ADDENDUM NUMBER 03

DATE: February 11, 2022
PROJECT: MHS Band Room Acoustics Project 2022
PROJECT NUMBER: 21-1403
OWNER: School City of Mishawaka
ARCHITECT: Abonmarche
315 W. Jefferson Blvd.
South Bend, IN 46601
TO: Prospective Bidders

No.	Drawing Title	Issue Date
A5.1	BUILDING SECTIONS & DETAILS	02-11-2022

4 SECTION @ BAND REHEARSAL ROOM - DETAIL (ALTERNATE #6)
A5.1 SCALE: 1" = 1'-0"

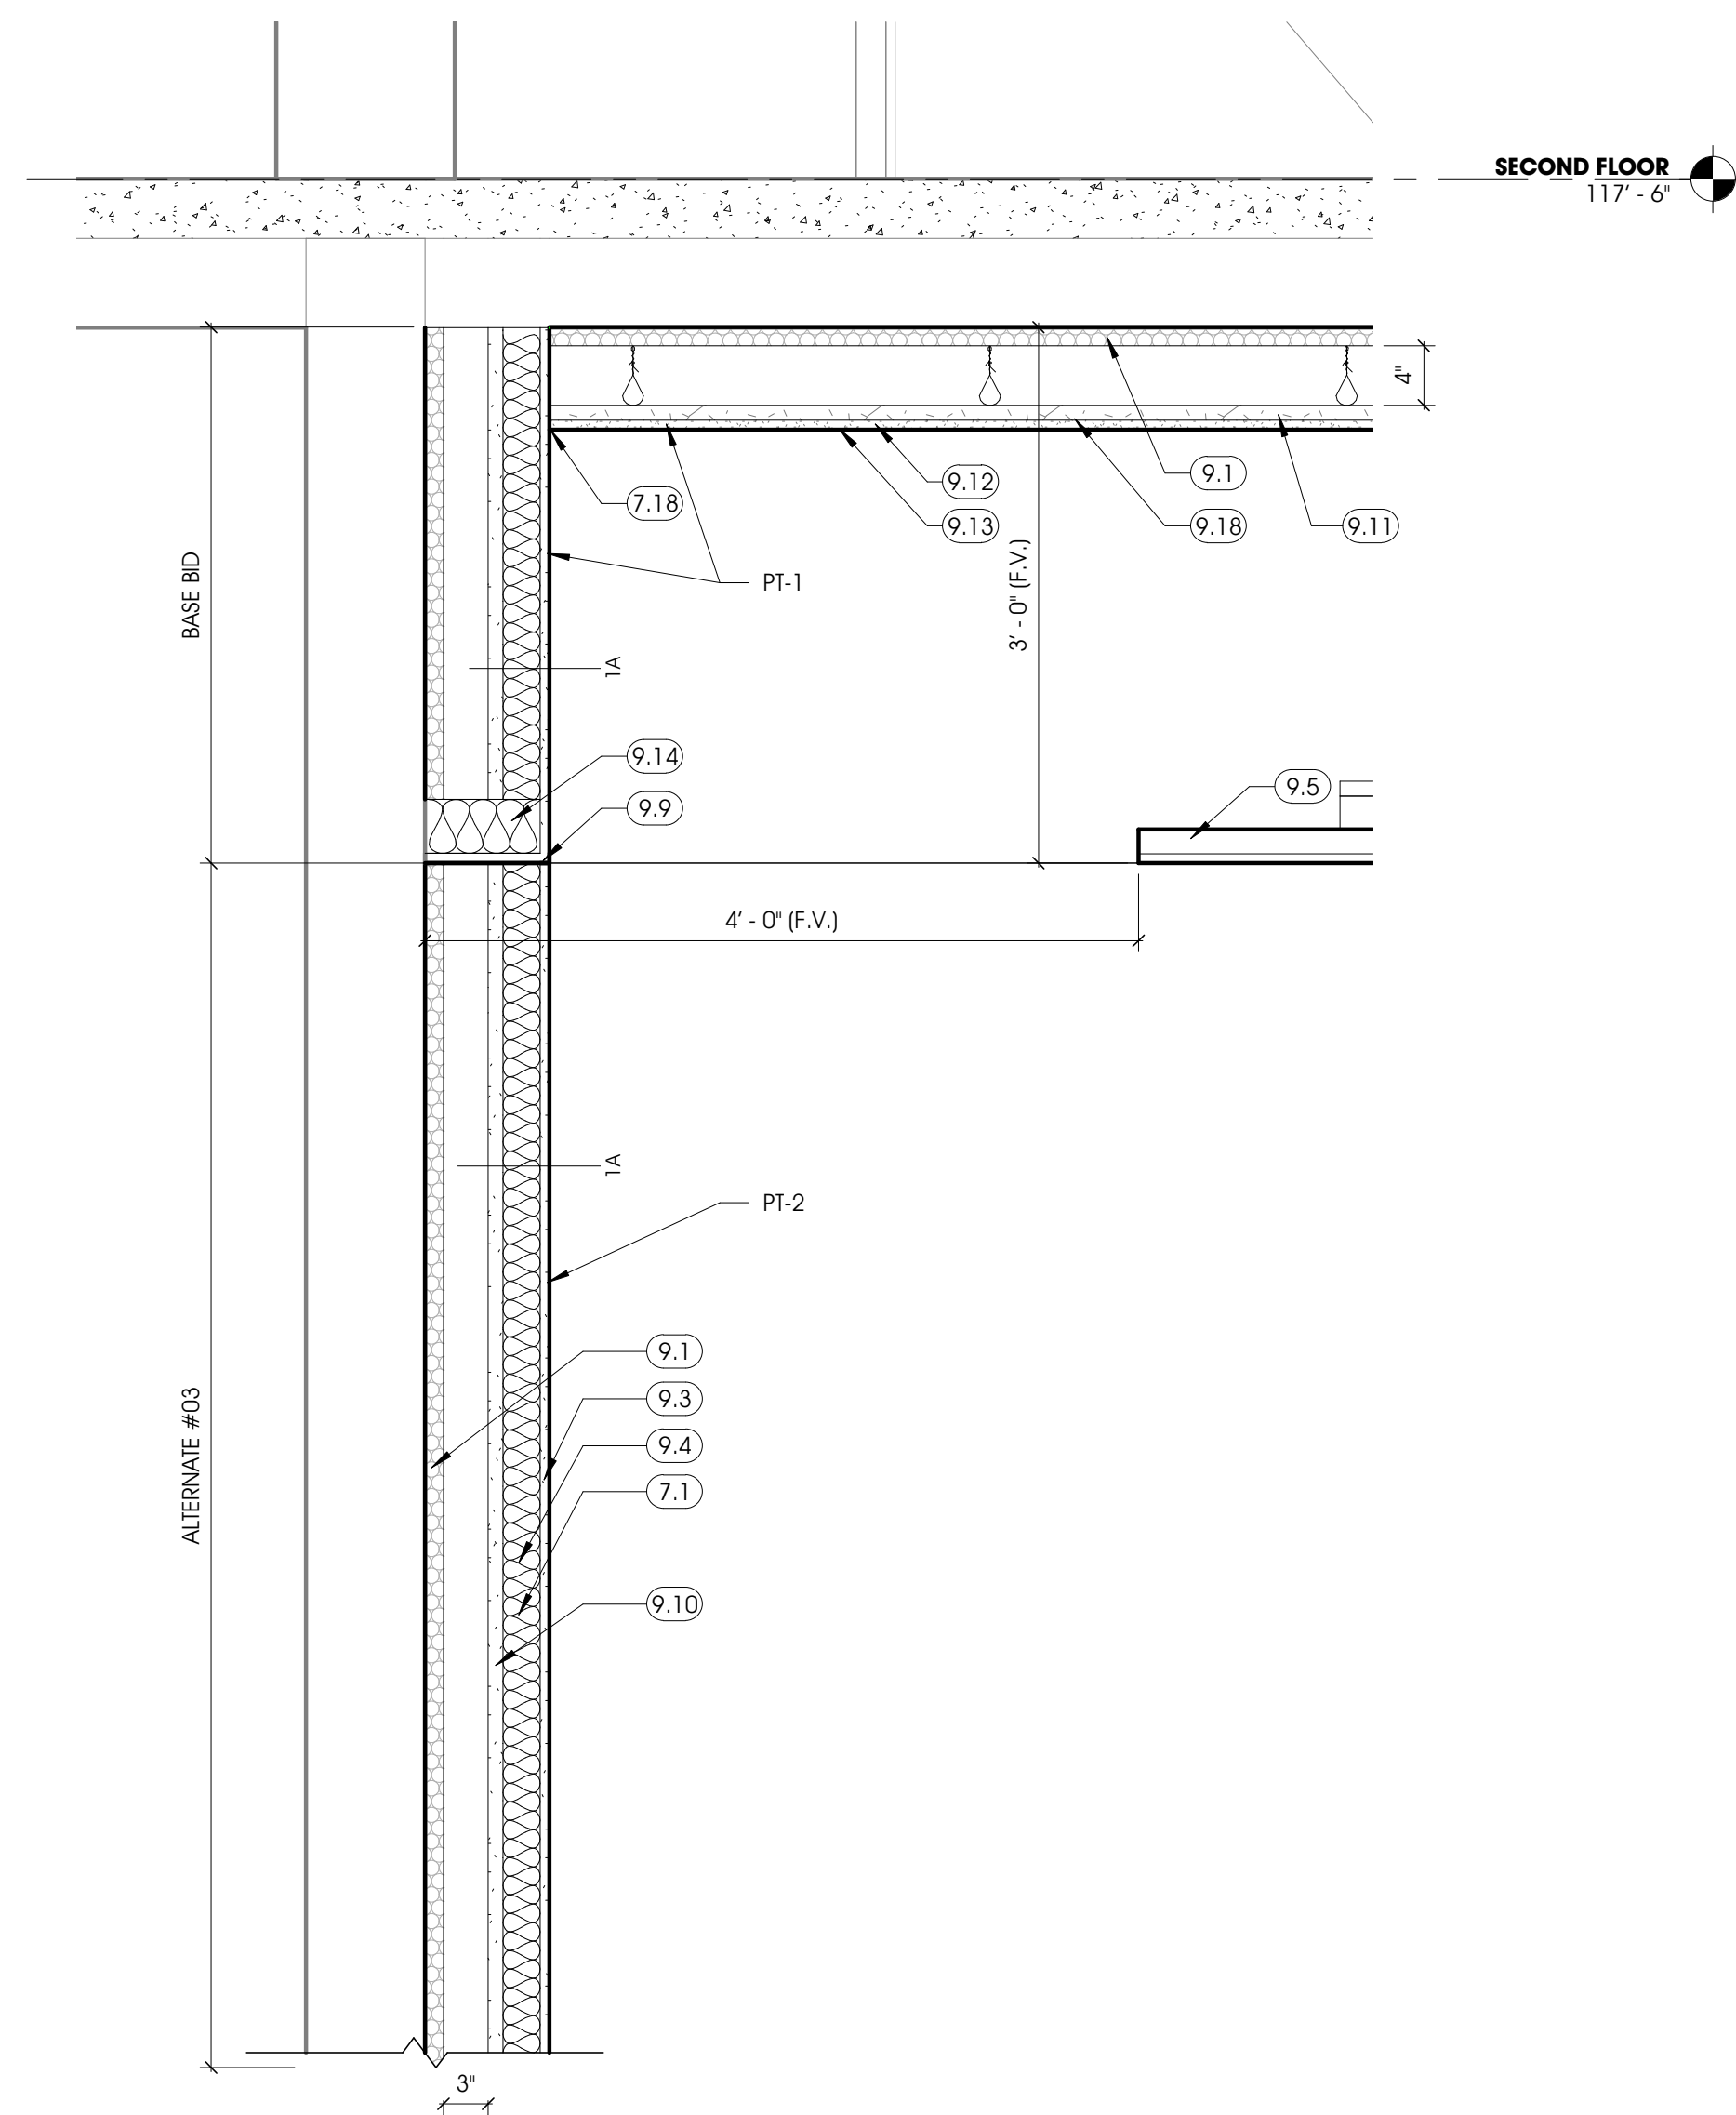
3. **REVISE** Detail 2 – SECTION @ BAND REHEARSAL ROOM – DETAIL
4. **ADD** Detail 4 – SECTION @ BAND REHEARSAL ROOM – DETAIL (ALTERNATE #6)

1. Base Bid: Provide new suspended acoustic drywall ceiling in Band Room.
2. Alternate: In lieu of Base Bid, provide direct installed acoustic drywall ceiling. Refer to Detail 4/A5.1.
